MANDATORY REFERRAL NO. MR2025023

METROPOLITAN BRANCH TRAIL UPGRADES

Mandatory Referral review for the design of upgrades to the Metropolitan Branch Trail within the City of Takoma Park.

COMPLETED: 08/27/2025

Figure 25: Plan View Proposed Improvements - Fenton Street/Takoma Avenue Intersection

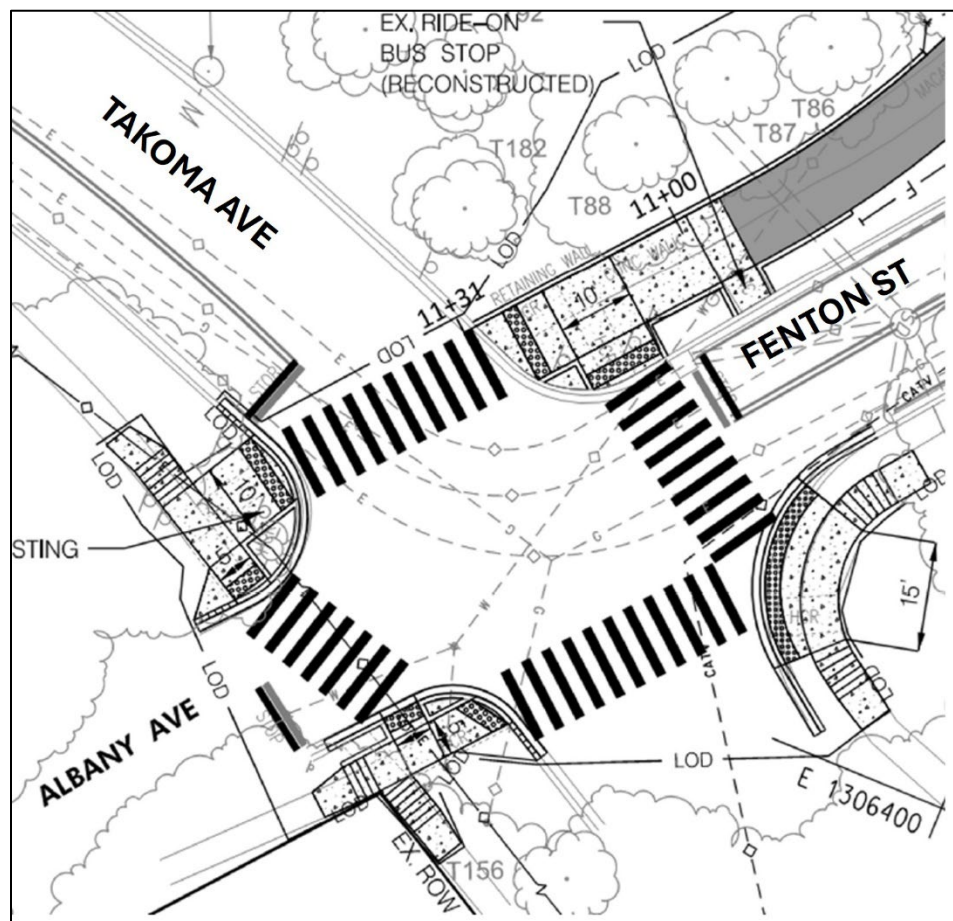
The crosswalks at the intersection of Fenton Street with Takoma Avenue are flush, not raised, crosswalks. The north leg of Takoma Avenue is classified as an Area Connector, formerly classified as a residential street, while Fenton Street is a higher-classification Downtown Street.

Recommendation: All crosswalks within the project limits should be designed as raised crosswalks consistent with Pedestrian Master Plan Key Action B-3c.

Figure 26: Proposed Plan View - Takoma Avenue/Buffalo Avenue Intersection

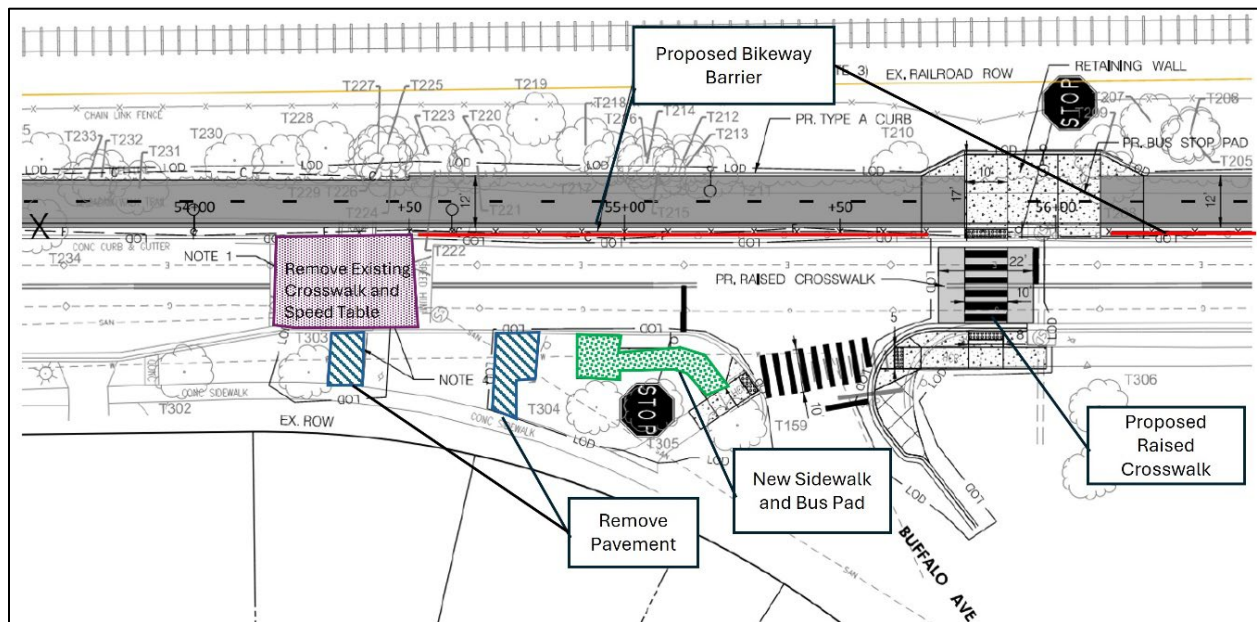
The proposed crosswalk on Buffalo Avenue at Takoma Avenue is a flush, not raised, crosswalk. Buffalo Avenue is a Neighborhood Street, formerly classified as a residential street, and the intersecting portion of Takoma Avenue is a higher-classification Area Connector.

Figure 29: Northwest Intersection Corner with Shared Curb Ramp - Fenton Street/Takoma Avenue

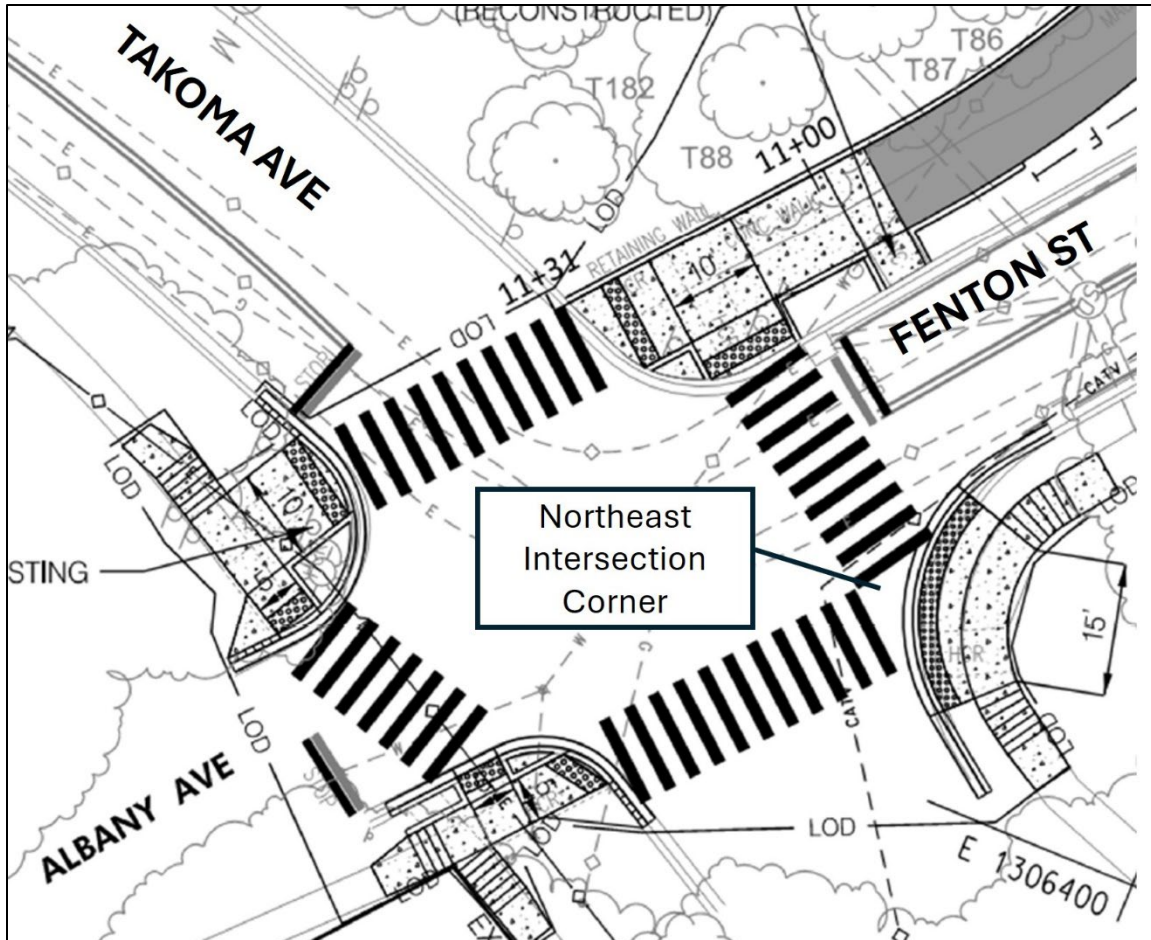
Recommendation: Every curb ramp along Fenton Street and Takoma Avenue within the project limits should be made ADA compliant. This includes both the use of directional ramps and appropriate design requirements. There is only one existing curb ramp that currently does not meet ADA requirements (the northeast corner of the intersection of Fenton Street with Takoma Avenue), and the proposed design does not propose changes to this ramp. The preferred intersection curb ramp standard is two perpendicular curb ramps per corner, each aligning with desired paths of travel. This helps to direct people with visual disabilities to cross the street in the crosswalk. The project retains a single curb ramp at the northeast corner of the intersection of Fenton Street with Takoma Avenue (see Figure 29).

Recommendation: Modify the northeast corner at the intersection of Fenton Street with Takoma Avenue to provide directional curb ramps to each crosswalk. This might require shifting the proposed crosswalk on the north Fenton Street leg to the north in order to fit these two directional ramps into the corner. It might also allow for a tighter corner radius to be constructed here.

Figure 30: Proposed Sidewalk Connection to Buffalo Avenue Bus Stop

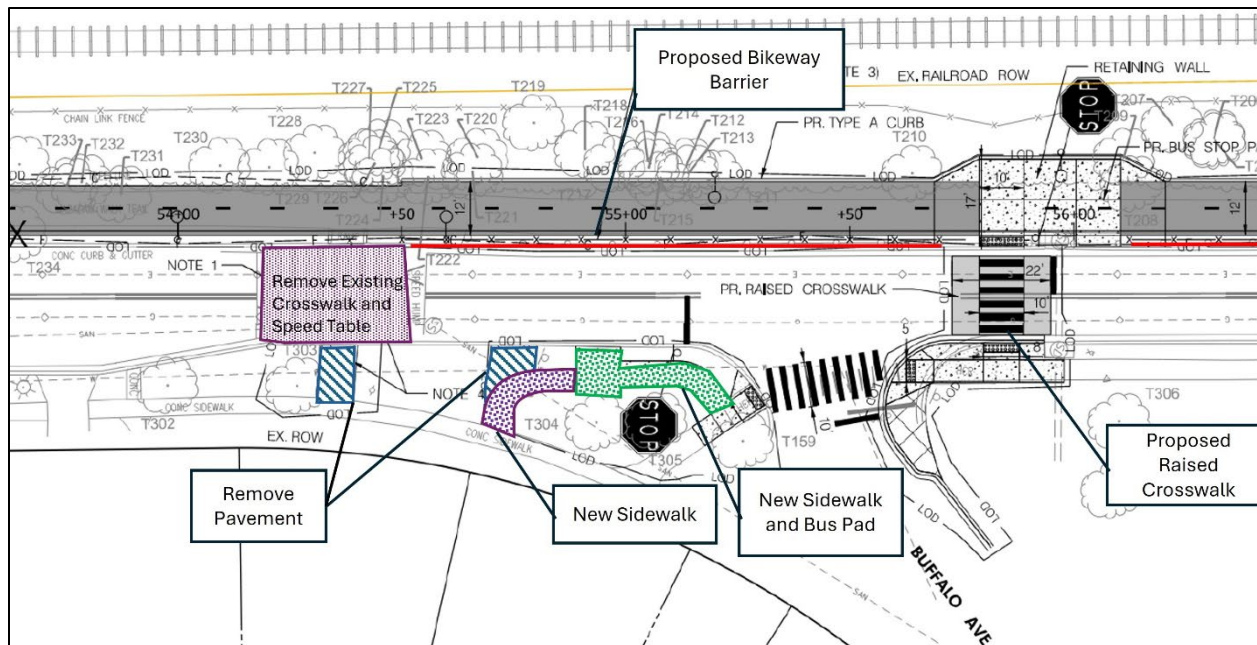
Pedestrian access to the proposed northbound Ride On bus stop at Buffalo Avenue will not provide an intuitive path for individuals with visual impairments.

Recommendation: Provide an additional sidewalk connection (shown in purple in Figure 30) to direct pedestrians arriving from the south to the Takoma Avenue Ride On bus stop south of Buffalo Avenue.
